Planning Commission Staff Report

Project Type: Site Development Section Plan

Description: **Wings Corporate Estates, Lot 14:** A Site Development Section Plan, Landscape Plan, Lighting Plan, Architectural Elevations and an Architect's Statement of Design for a 1.61 acre tract of land zoned "PI" Planned Industrial District located on the east side of Eatherton Road, south of Wings Corporate Drive.

RE: Wings Corporate Estates Lot-14 – Architects response to ARB questions.

NORTH ELEVATION
1/8"=1'-0"

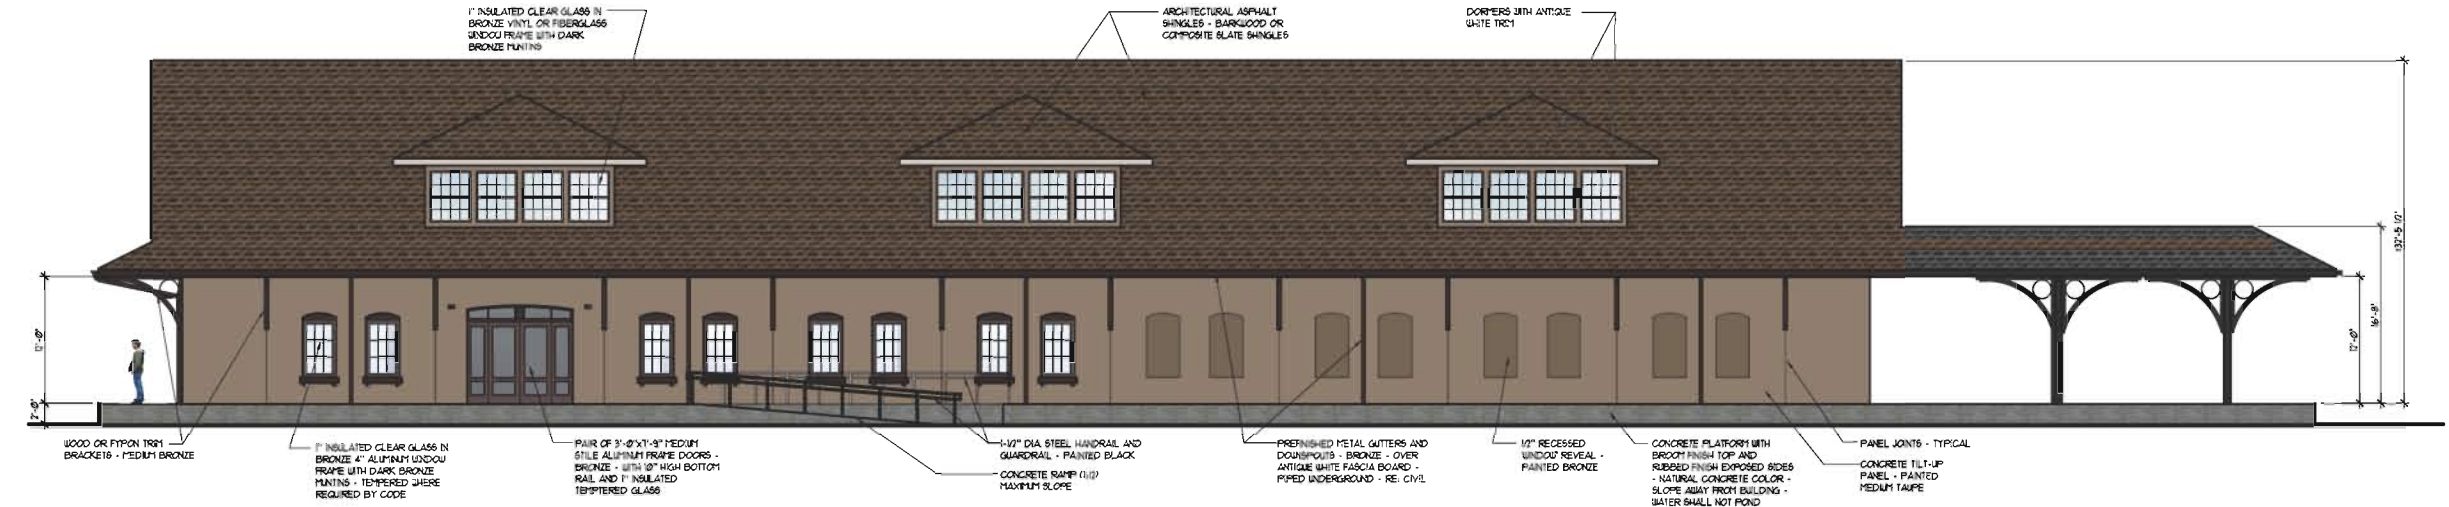
- 5) Provide details on whether gutter downspouts will be needed on the front porch and how they will affect design.

Response: Thank you for this comment. The gutters and downspouts were negligently left off of the design. Please see the attached revised clarification drawings to resolve this issue.

- 6) (not numbered on City letter) – The windows on the north elevation, including in the dormers are unitized windows, (single hung type) not stick built. These will have clear, low E glass. The entry, the

SOUTH ELEVATION
1/8"=1'-0"

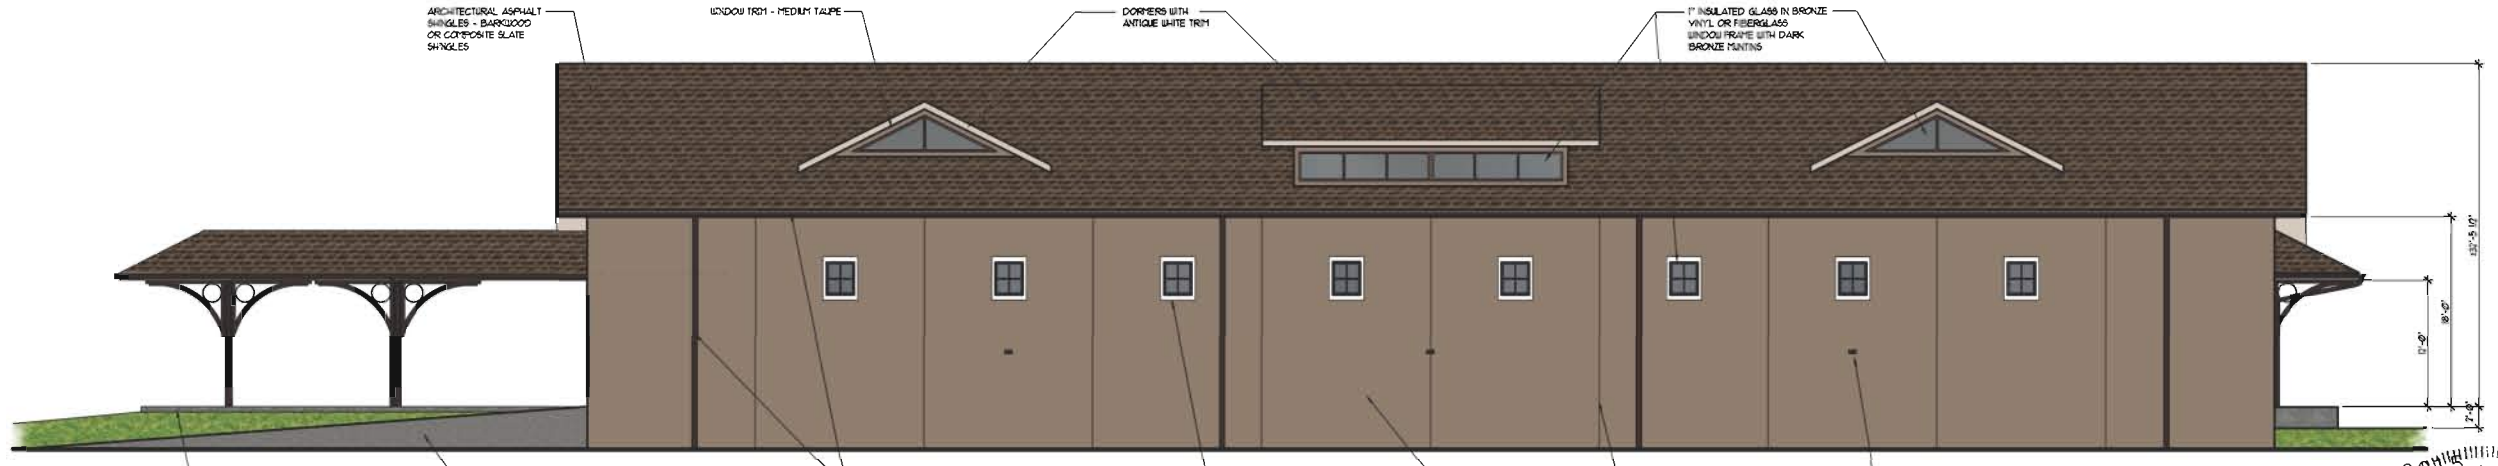
- 3) Consider matching the design of the dormers on the rear of the building with those on the front of the building.
- 4) Consider enlarging the size of the windows on the south façade and adding additional articulation on this façade.
- 5) Provide details on whether gutter downspouts will be needed along the front porch/platform and how they will affect the design.

- 4) Consider enlarging the size of the windows on the south façade and adding additional articulation on this façade.

Response: The windows in question are intentionally kept small. Their actual purpose is to let light into the warehouse above any racking that may exist. As to the lack of articulation, the elevation as a mass is our design intent. We do not wish to simply add reveals or other elements out of that old design toolbox.

EAST ELEVATION
1/8"=1'-0"

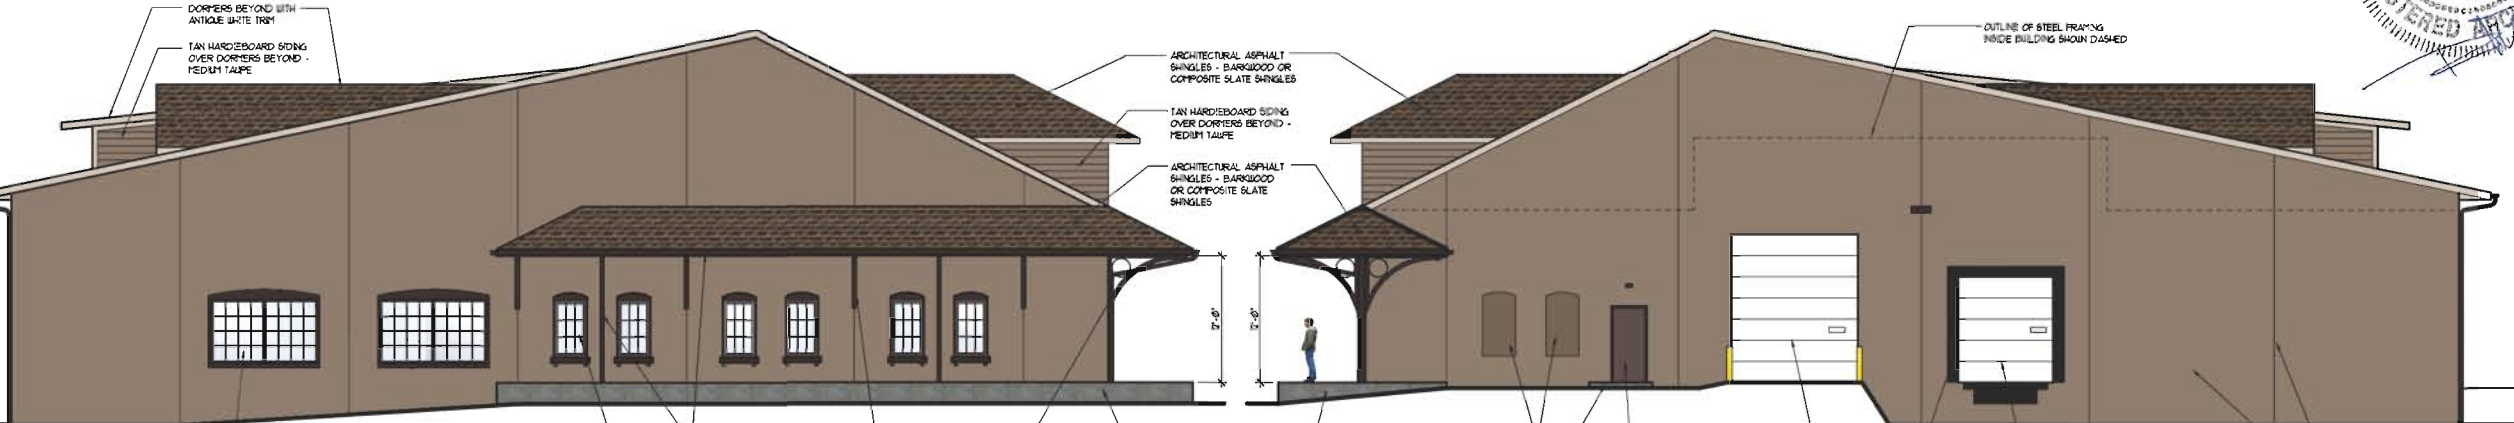
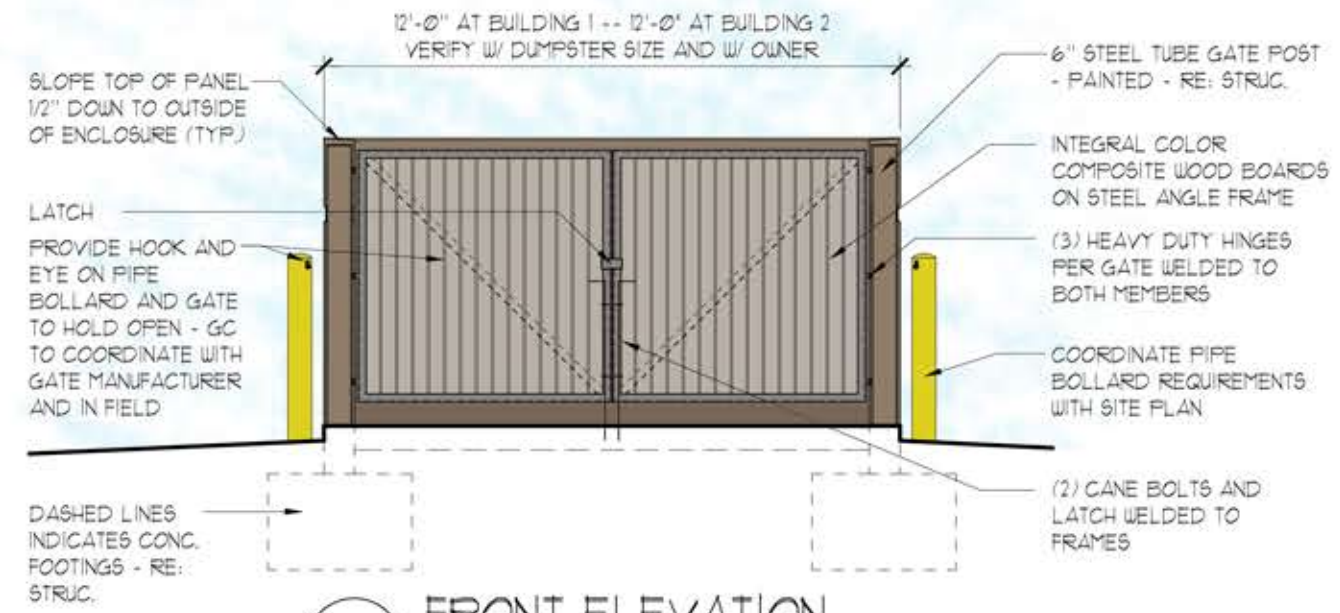
- 2) Consider making the roofline more symmetrical when looking at the east and west elevations, or add elements to give the perception of symmetry.

Response: Symmetry as a design goal has its place in classical and in other historical architecture. However, in the history of train stations, we believe that the function was the goal and that the design grew out of its environment. The asymmetrical shape of this building is not merely a design thought that was pulled from thin air. On the contrary, the geometry of the roof was a direct result of the great depth of the roof overhanging the rail platform. If the ridgeline were centered on the building, the slope and overhang of the platform roof would not work out. So, as in history, the practical nature of this design predicated the end results. "A proper building grows naturally, logically and poetically out of all of its conditions". *Louis Sullivan*

Simply adding a 'fake' eave line to 'be more symmetrical' like so many homes in the area is not desirable.

We respectfully decline this suggestion.
